**REPUBLIC OF MOLDOVA  
ROAD SECTOR PROGRAM**

**CLARIFICATION DOCUMENT No.1**

**Answers to the Requests for Clarification received  
from prospective Tenderers**

**Road Rehabilitation & Construction Works under two Lots**

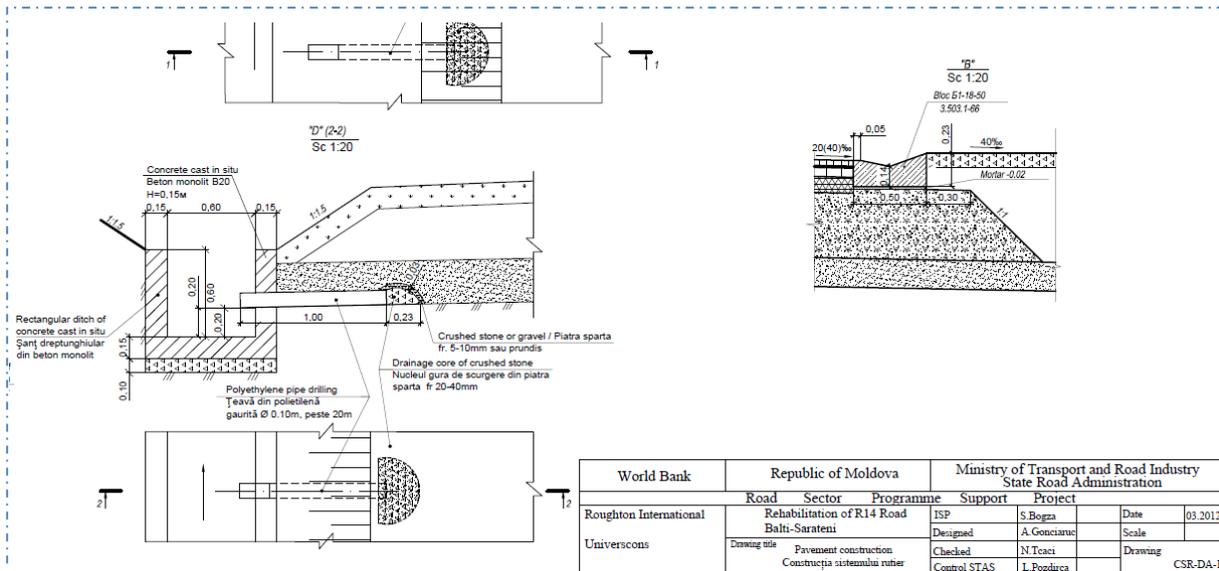
**Drainage. Drawing SLT-DA-2** with concrete units 0.60x0.60m does not comply with BoQ Item 5.13 “New construction of lined side drain Type 4 with precast concrete units and/or concrete cast in situ rectangular 0.60x0.45”. Please indicate correct size of those units.

The BOQ description is revised to match the Technical Specification, as follows:

50308	New construction of Lined side drain Type 4 with precast concrete units and/or concrete cast in situ rectangular 0.60 x 0.60.	Lin.m
-------	---	-------
